MFN 07-019

**Subject: Response to Portion of NRC Request for Additional Information  
Letter No. 70 Related to ESBWR Design Certification Application –  
Initial Test Program – RAI Numbers 14.2-39 and 14.3-82**

**Initial Test Program – RAI Numbers 14.2-39 and 14.3-82**

Figure 2.2-2-1. Control Rod Drive System

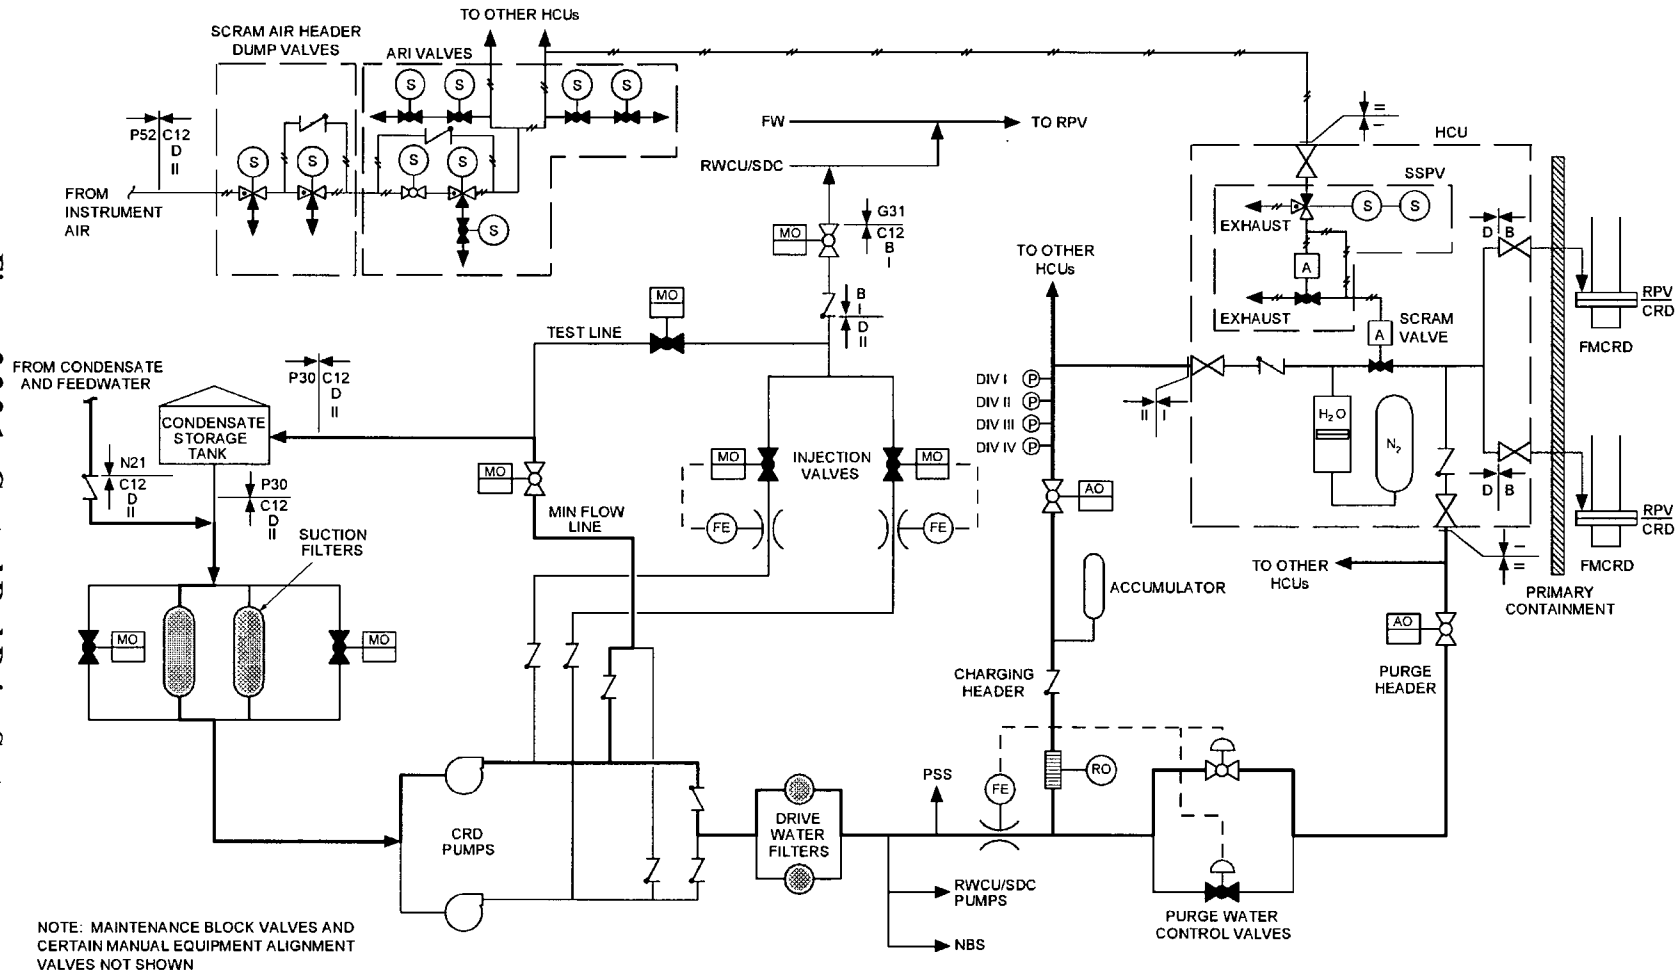
*Please revise DCD Tier 1, Figure 2.2.2-1, Control Rod Drive System, to show the HCU Charging Header pressure instrumentation.*

The charging header pressure instrumentation will be added to DCD Tier 1, Figure 2.2.2-1 and DCD Tier 2, Figure 4.6-8 as shown in the attached markup.

DCD Tier 1, Figure 2.2.2-1 and DCD Tier 2, Figure 4.6-8 will be revised as noted in the attached markups.
